PIC16C73B Rev. A Silicon Errata Sheet

The PIC16C73B (Rev. A) parts you have received conform functionally to the Device Data Sheet (DS30605A), except for the anomalies described below.

FIGURE 1: $\overline{\text{MCLR}}$ EXTERNAL CIRCUIT

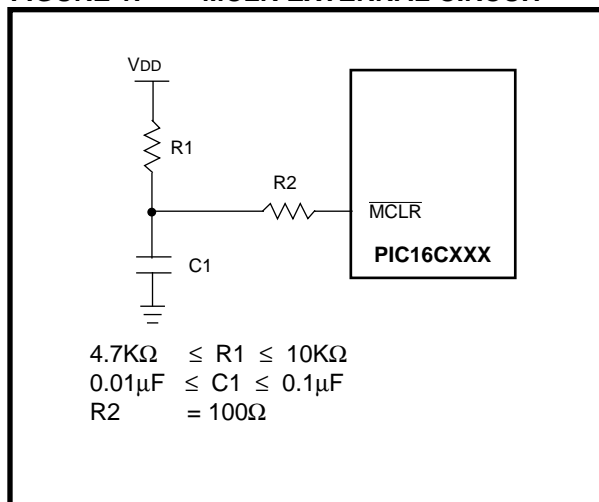
The minimum specification for the $\overline{\text{MCLR}}$ must be met in order to RESET the PIC16CXXX. If a $\overline{\text{MCLR}}$ pulse occurs that is less than the minimum specification (parameter #30), improper device operation can occur.

If the Minimum specification cannot be met, then an external circuit must be used to insure that any pulse width less than the specification will be filtered before it reaches the $\overline{\text{MCLR}}$ pin.

A possible circuit is shown in Figure 1. Proper design validation needs to be done to ensure desired operation over the applications operating conditions

Figure 1: Wake-up from Sleep

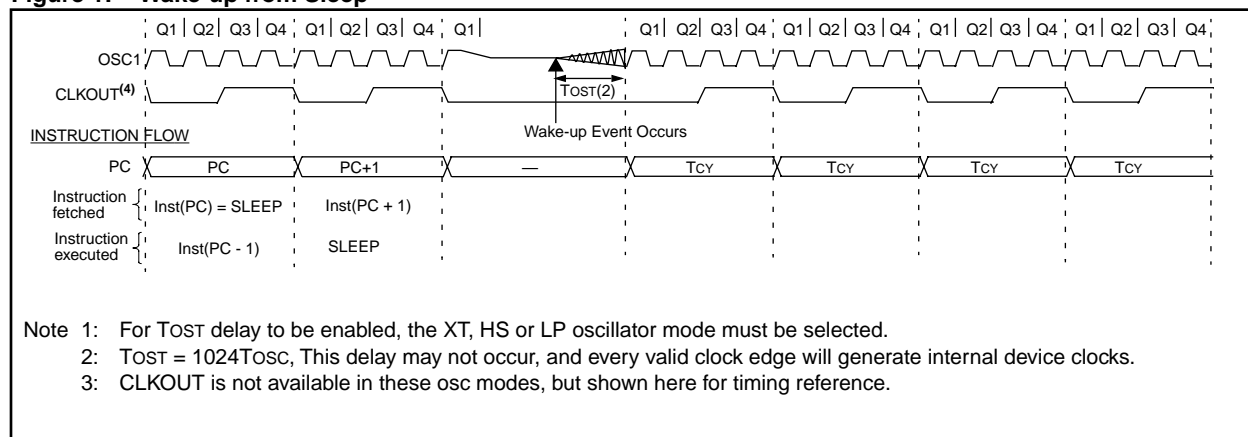
The Oscillator Start-up Timer (TOST) delay may not occur when the device wakes-up from sleep.

Figure 1 shows the start-up of the crystal after the event that causes the device to wake up from sleep mode (as specified in device data sheet). The start-up time (TOST) may not occur.

In applications where time based measurements are started immediately after wake-up from sleep, the suggested work around should be implemented.

After the SLEEP instruction, do a software delay of 256 Tcy (same as 1024 TOSC). At the Reset and Interrupt vector addresses, test to see if the device woke from sleep (the $\overline{\text{TO}}$ and $\overline{\text{PD}}$ bits), and if the device did wake from sleep, ensure that the total cycle delay is 256 Tcy.
